# UNITED STATES PATENT AND TRADEMARK OFFICE

| APPLICATION NO.   | FILING DATE | FIRST NAMED INVENTOR | ATTORNEY DOCKET NO.               | CONFIRMATION NO. |
|---|-------------|----------------------|-----------------------------------|------------------|
| 10/774,314  | 02/06/2004  | Shlomo Novotny       | SUN.04.142                        | 8526             |

| <b>Office Action Summary</b> | <b>Application No.</b><br>10/774,314 | <b>Applicant(s)</b><br>NOVOTNY, SHLOMO |  |

## **DETAILED ACTION**

FIG. 2

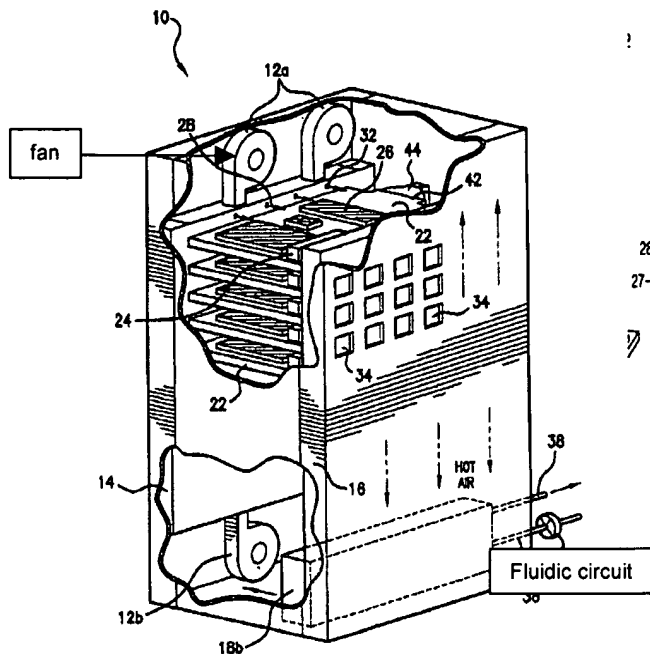
- With respect to claim 1, Patel et al. disclose an electronic component system comprising: an enclosure (10); one or more electronic components positioned within the enclosure (22, 24), at least one fan (12a, 12b) positioned within the enclosure for generating an airflow across the one or more electronic components (paragraph 0031), a heat exchanger for cooling the airflow (18a, 18b, paragraph 0026).

Patel et al. do not disclose a phase change material for absorbing heat from the airflow upon a failure associated with the heat exchanger.

Fig. 6

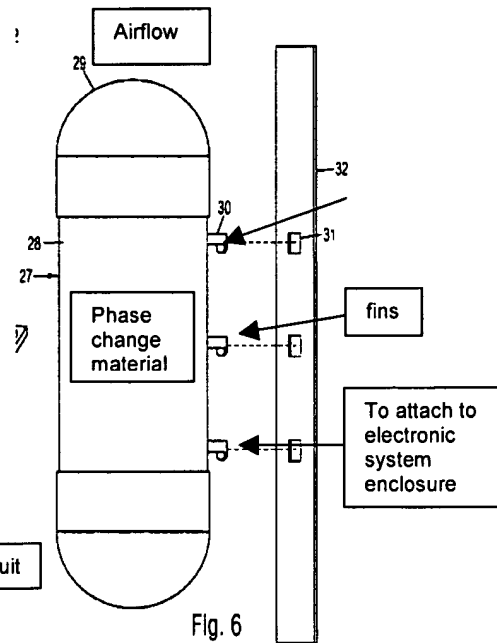
O'Grady (US patent 6,170,561) disclose a back up cooling device for electronic components comprising a phase change material for absorbing heat from the airflow upon a cooling system failure associated with electronic component systems. It would have been obvious to one of ordinary skill in the art at the time the invention was made to create a system for permitting orderly shutdown of electronic components by incorporating the phase change material taught by O'Grady in the electronic component system disclosed by to Patel et al., so as to provide repair time by delaying electronic component failure after cooling system failure (O'Grady, column 2, lines 25-30).

- With respect to claim 8, O'Grady further discloses that the container includes fins (O'Grady, Fig 6, "30").
- With respect to claim 11, Patel et al. further discloses a temperature sensor for sensing temperature within the enclosure; and a high temperature indication indicative of a high temperature within the enclosure (Patel et al., Paragraphs 0033-0035), the high temperature being lower than a phase change temperature of the phase change material (O'Grady, lines 50-55).

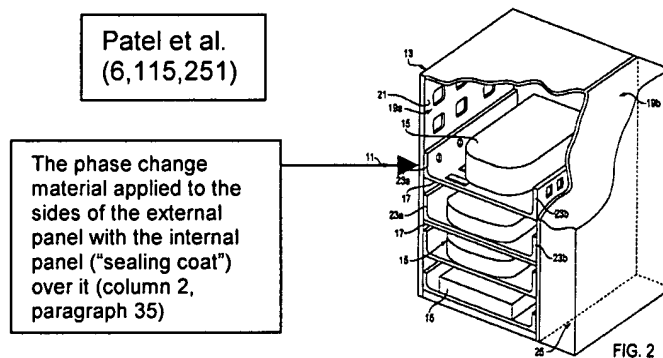
- Regarding claim 9, Patel et al. do not disclose the phase change material to be in micro-encapsulated form that is embedded in a coating applied to one or more of the surfaces within the enclosure. Fitch et al. disclose a phase change material in micro-encapsulated

form that is embedded in a coating applied to one or more surfaces within an electronic system enclosure (Fitch et al., figure 8, column 5, lines 4-7). At the time the invention was made, it would have been obvious to one of ordinary skill in the art, to incorporate the micro-encapsulated phase change material coated on multiple surfaces of the enclosure as taught by Fitch et al., on the system as taught by Patel et al., to make utilize the additional cooling capabilities of the micro-encapsulated surface coating without a significant increase in weight, size and cost (Fitch et al., column 3, lines 10-15).
